Access Compliance Report

Public Rights-of-Way

Intersection ID: 25129	Main Street: BROOKNELL_TR	Cross Street: WINDING_OAK_DR	Location: SE
ADA ID: 33D9B95E84F0	Ramp Type: PerpDiag	Initial Pass/Fail: Fail	Overall Compliance: No
		Severity Score: 12.5

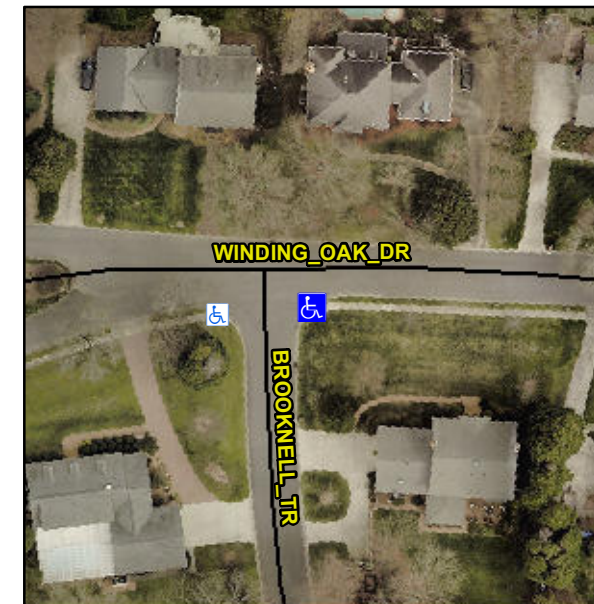
Not Found, R304.2.2

Compliance	Description	Data	Compliance	Description	Data
N/A	Ramp Length (in)	48.0	No	Ramp Slope (%)	10.2
Yes	Ramp Width (in)	48.0	Yes	Ramp XSlope (%)	1.9
N/A	Flare Type LT	N/A	N/A	Flare Type RT	N/A
N/A	Flare Slope LT (%)	N/A	N/A	Flare Slope RT (%)	N/A
N/A	Flare Traversable LT?	N/A	N/A	Flare Traversable RT?	N/A
N/A	Landing Length (in)	N/A	N/A	DWS Provided?	N/A
N/A	Landing Width (in)	N/A	N/A	DWS Contrast?	N/A
N/A	Landing Slope (%)	N/A	N/A	DWS Length (in)	N/A
N/A	Landing X Slope (%)	N/A	N/A	DWS Full Width?	N/A
N/A	Landing Curb? (Y/N)	N/A	N/A	DWS Offset (in)	N/A
N/A	Shared Landing?	N/A			
N/A	Gutter Ponding?	N/A	N/A	Gutter Slope (%)	N/A
N/A	Gutter Lip Ht (in)	N/A	N/A	Gutter X Slope (%)	N/A
N/A	Painted X Walk1?	No	N/A	Painted X Walk2?	No
	X Walk 1 Direction	To N		X Walk 2 Direction	To W
N/A	X Walk 1 Width (in)	N/A	N/A	X Walk 2 Width (in)	N/A
	X Walk 1 Slope (%)	1.6		X Walk 2 Slope (%)	0.9
	X Walk 1 X Slope (%)	0.2		X Walk 2 X Slope (%)	1.9

Remove & Replace Curb Ramp With Two New Directional Ramps or Equivalent.
